**Town of Kittery
Planning Board Meeting
November 17, 2016**

412 Haley Road – Preliminary Plan – Completeness Review

Action: Accept or deny application. Schedule a public hearing. Owner Marilyn Mann & James Smith, and applicant, Green & Company, requests consideration of a 12-lot cluster subdivision located at 412 Haley Road (Tax Map 34 Lot 3) in the Residential-Rural (R-RL) and Shoreland Overlay (SH-OZ-250') Zones. Agent is Joseph Coronati, Jones and Beach Engineers, Inc.

DRAWING No.
OV2
SHEET 3 OF 15
JBE PROJECT NO. 16030

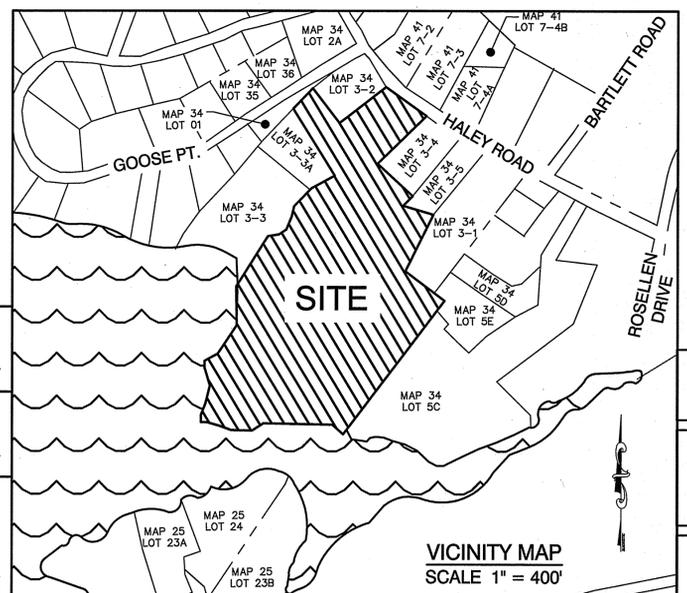
5. Net Residential Acreage (NRA) calculations are shown on the Overview Subdivision Plan (OV2), however, it does not appear to be a complete list of deducted land areas, as outlined in 16.7.8.2 Net Residential Acreage Calculation. For example, 16.7.8.2.K instructs the applicant to deduct "Fifty percent of all land characterized as drainage class of somewhat poorly drained, unless public sewer is used, in which case no land area is subtracted". The soil survey included with the stormwater management plan shows there are areas of somewhat poorly drained soil on the site, and the site is not connected to public sewer, however this does not appear to be included with the list of NRA deductions. Prior to holding a public hearing, the applicant should resubmit NRA calculations to clearly address each of the deducted land area criteria, as outlined in 16.7.8.2.
